# ORIEL WIND FARM PROJECT

## Environmental Impact Assessment Report - Addendum Appendix 28-4: Technical note on Cable Construction at M1

MDR1520C  
EIAR – Appendix 28-4  
A1 C01  
December 2025

**Figure 2 Predicted settlement with HDD depth below motorway road surface**

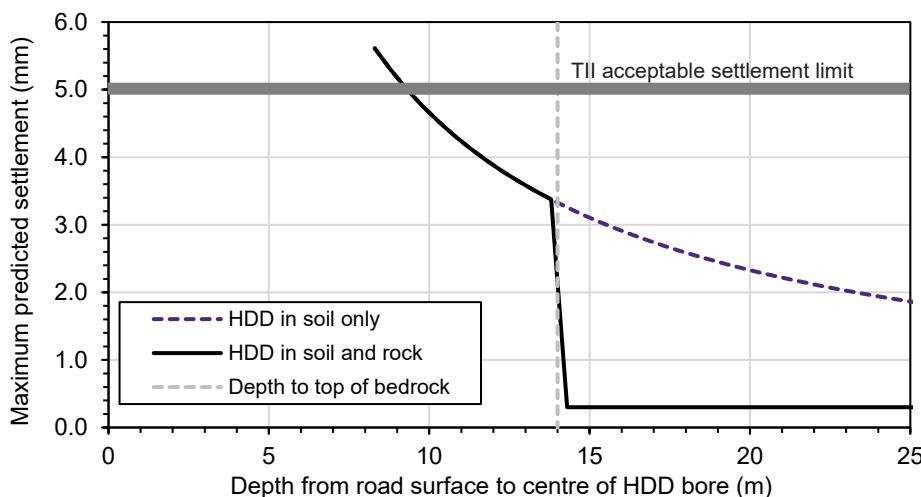
(2) *Provide vertical profile and further geotechnical details to show no risk to the embankment.*

Based on discussions with TII the settlement as a result of the HDD below the motorway is required to be kept to a minimum. Further detailed assessment of the predicted settlement due to the HDD works has been carried out to determine the predicted maximum settlement where the HDD is taken to greater depth below the motorway.

Below the motorway the glacial till is estimated at about 14 m thick overlying bedrock. Where the HDD is within bedrock the settlement would effectively be zero or a nominal amount. The predicted maximum settlement with an increase in HDD depth below the motorway road surface is provided in Figure 2 with details of predicted settlement assessment included in Annex D.

M1 & RAIL CROSSING HDD - GENERAL ARRANGEMENT BORE 1

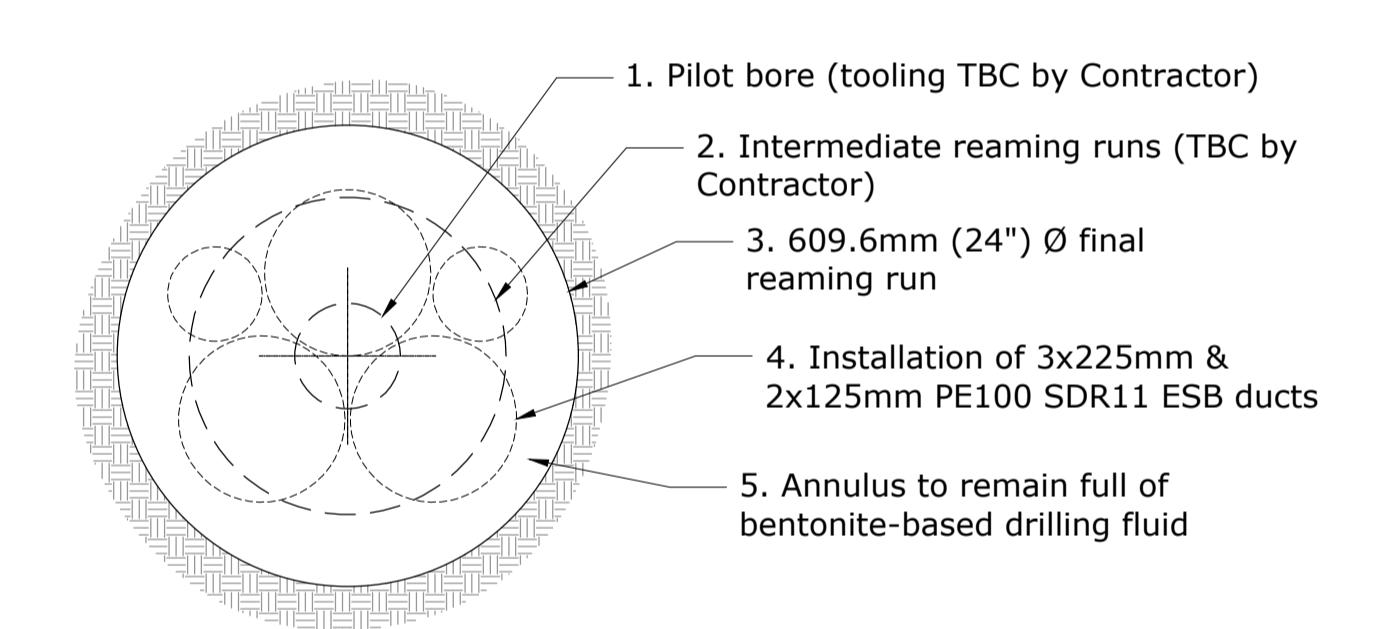
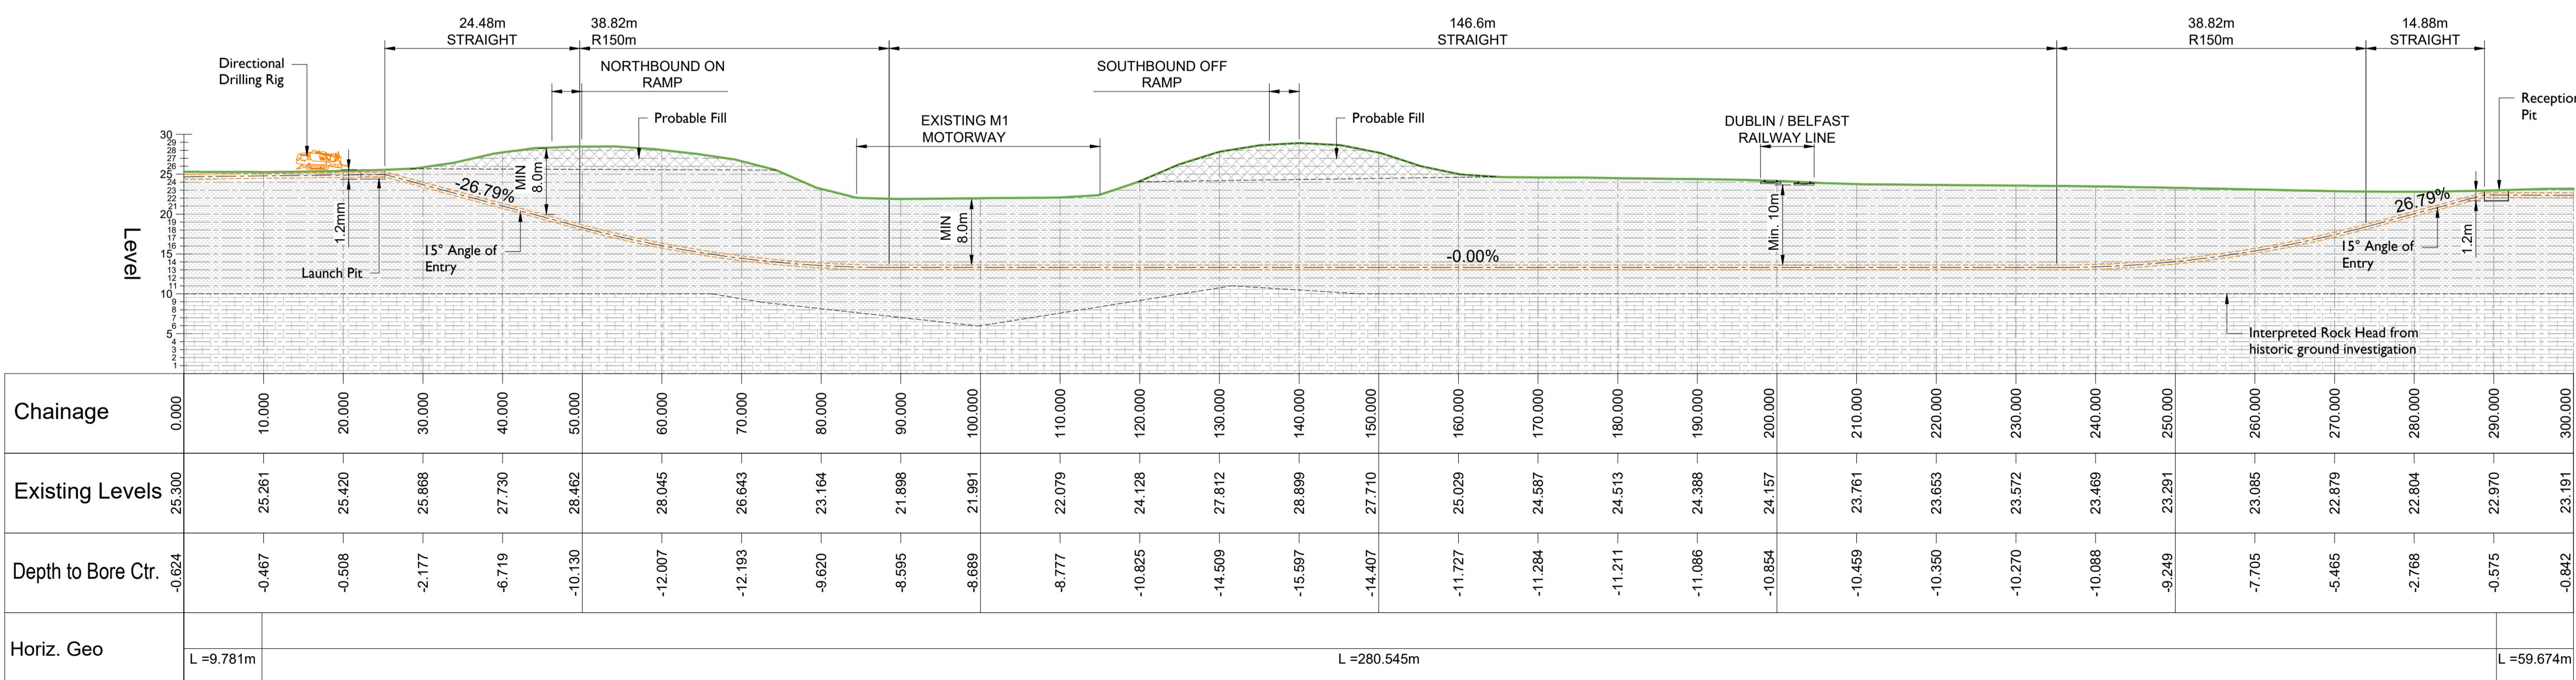
(3) *Include further details on construction methodology for this location.*

The indicative profile of the installation bore is shown on drawing provided in Appendix B. A summary of the profile is given below:

- Distance from the entry to exit pit will be approximately 265m.
- An entry and exit angle of 15 degrees is proposed to facilitate the rig being set up either side of the crossing.
- The ground level at the entry pit is approximately 25.5 mOD.
- At entry the vertical curve of the section drawing begins straight through the boulder clay, bending commencing in the boulder clay 11.5 m from entry at a radius of 150 m until the radius flattens out, continuing beneath the motorway and railway until approximately 50m from the exit where the pilot hole will rise at a 150m radius to surface until a 15 degree angle is achieved and finishes on a straight line to exit.
- The deepest point of the HDD profile is 13 mOD.
- The motorway level is ~21.8 mOD.
- The track level is ~24.1 mOD.
- The GL at the exit pit in the field to the east of the railway is 23.0 mOD.

The stability output showing the critical failure surfaces for each stability case are presented in Figure 3 to Figure 8 included in Annex C of this technical note.

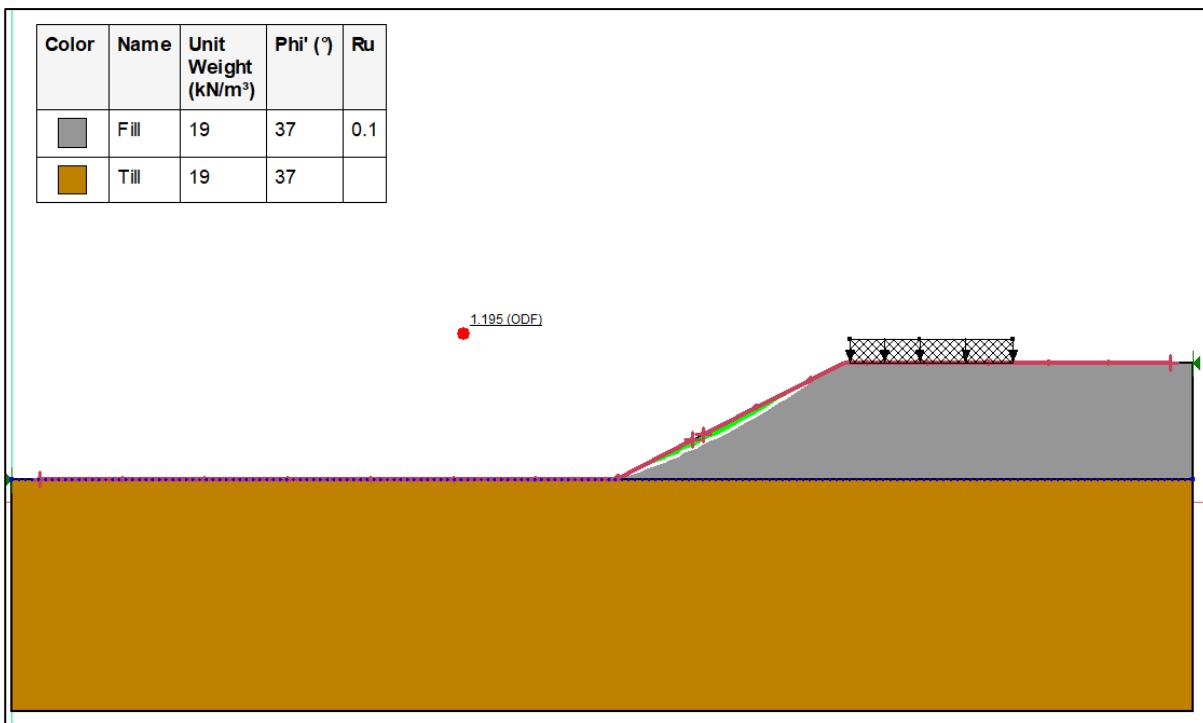
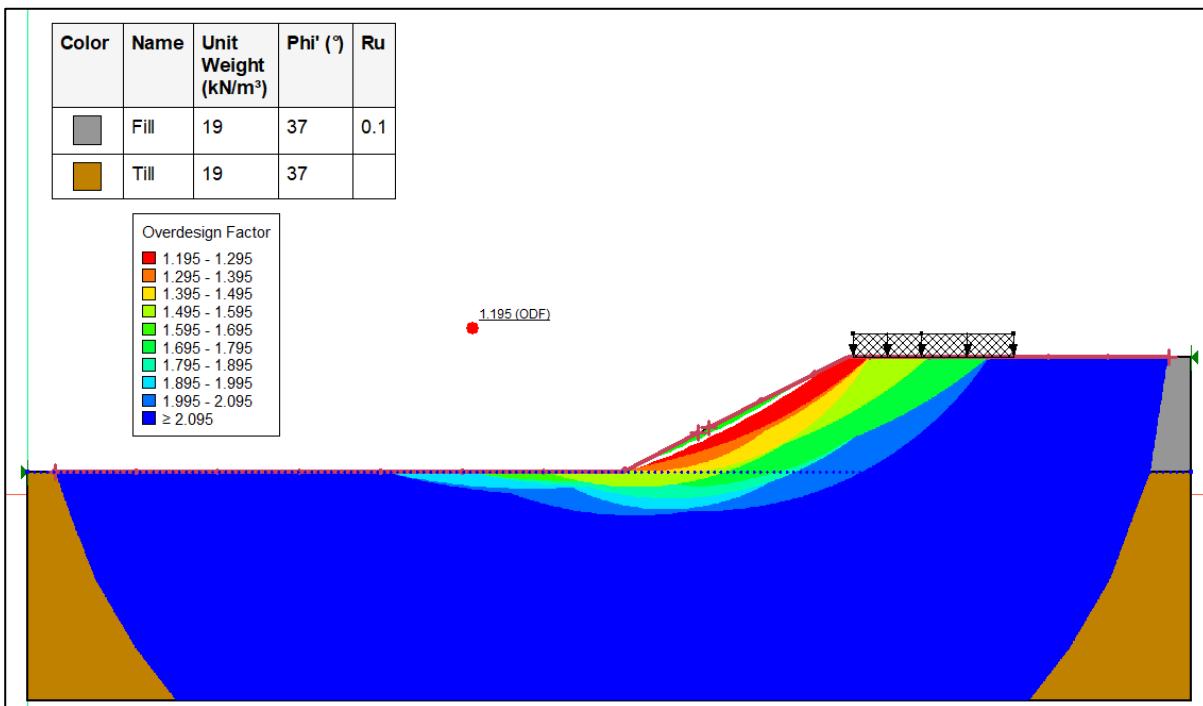
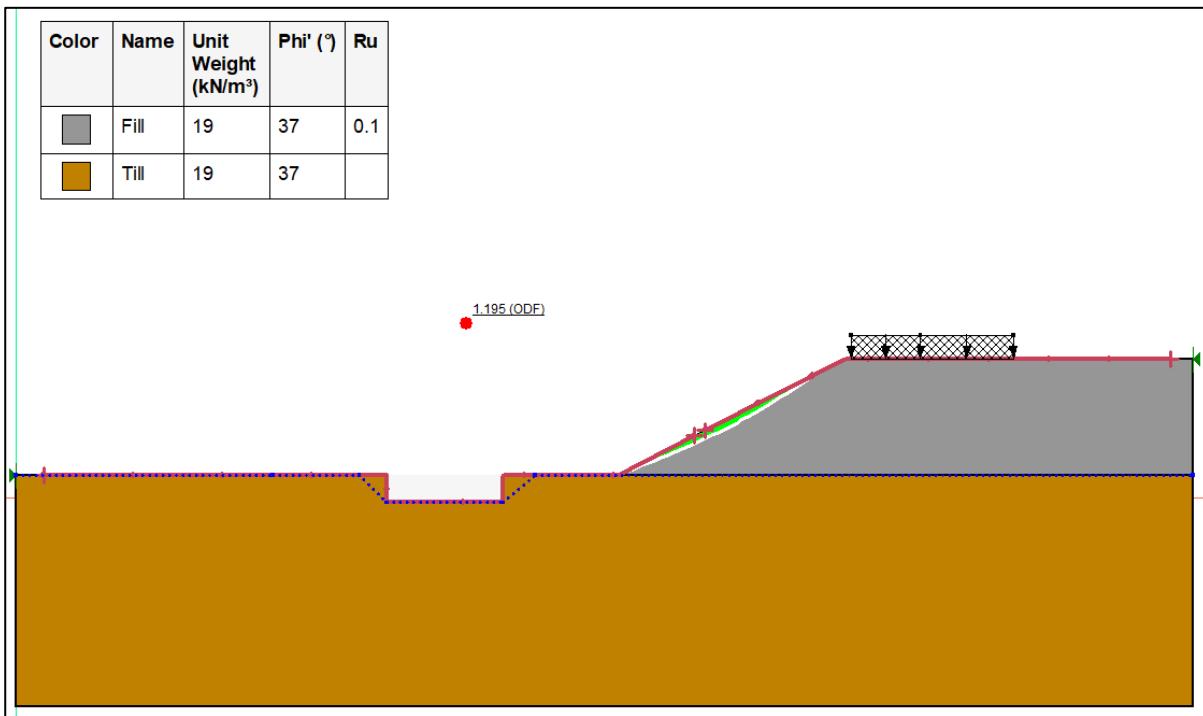
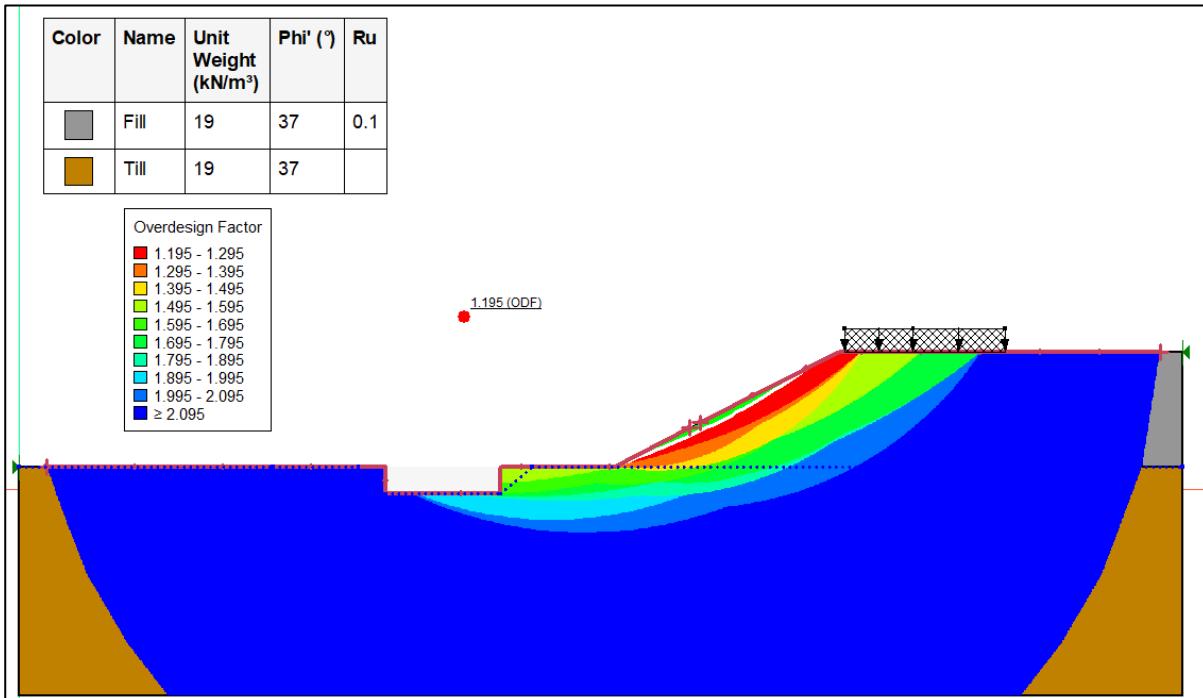
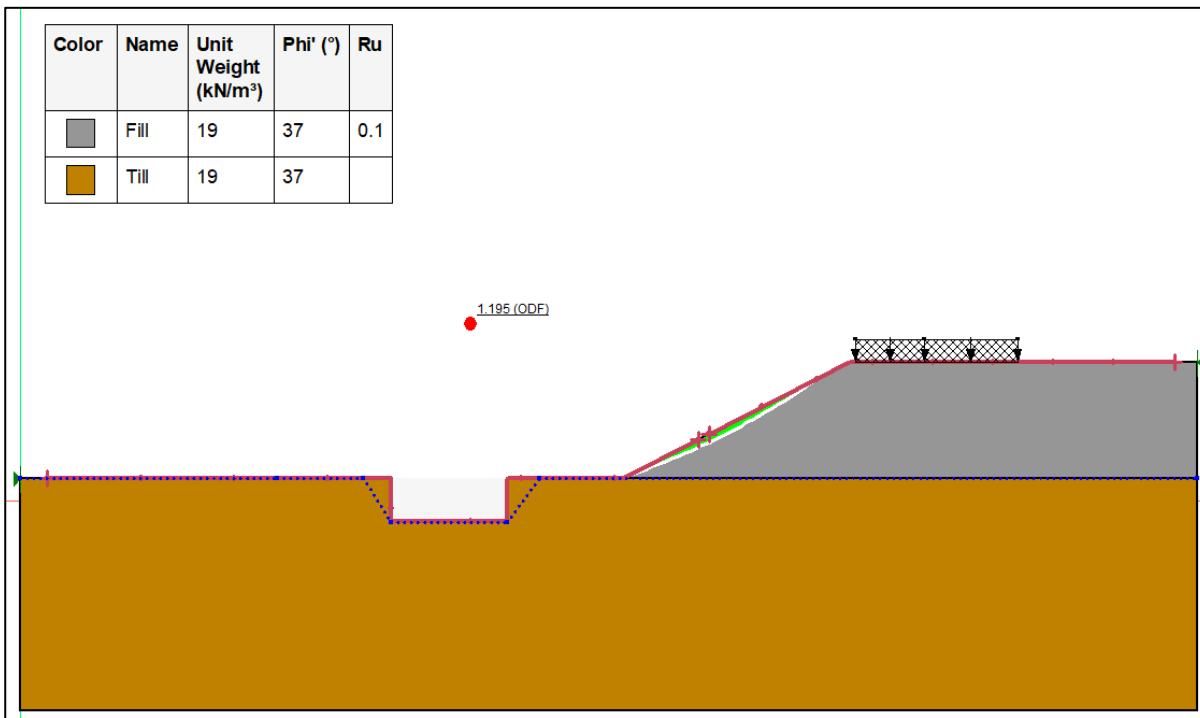
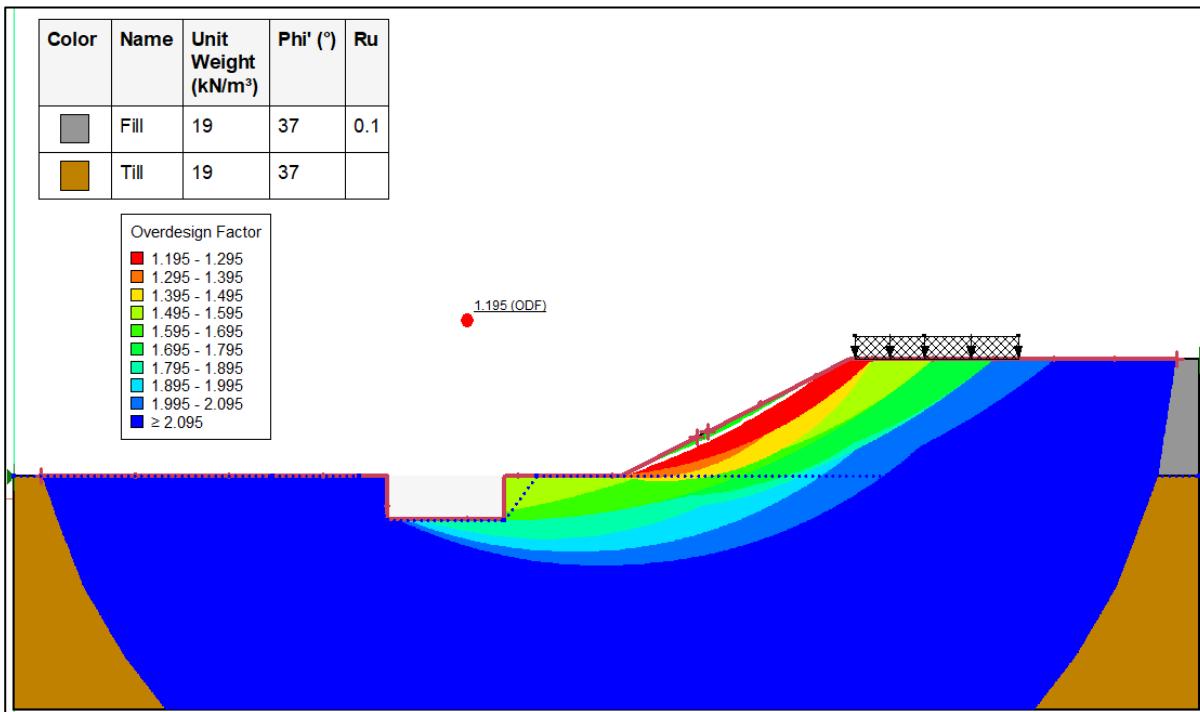
- (1) *The proposed pit to the west of the M1 is located very close to the embankment. There are concerns that the proposed pit and groundworks are in close proximity to the embankment. OWL/RPS to demonstrate the embankment will not be destabilised by the proposed pit and groundworks.*

The results of the stability analysis for the three cases are given in Table 1. The results show that there is no impact on the stability of the embankment slope as a result of the presence of the launch pit or the transition chamber, that is the ODF value for the slope does not change between the existing slope and the slope when the launch pit or transition chamber are present.

- (4) The analysis included an assessment of the stability with the proposed launch pit and the deeper transition chamber in place. The results of the stability analysis show that there is no impact on the stability of the embankment as a result of the proposed works, see Table 1 and Figure 3 to Figure 8 in Annex C.
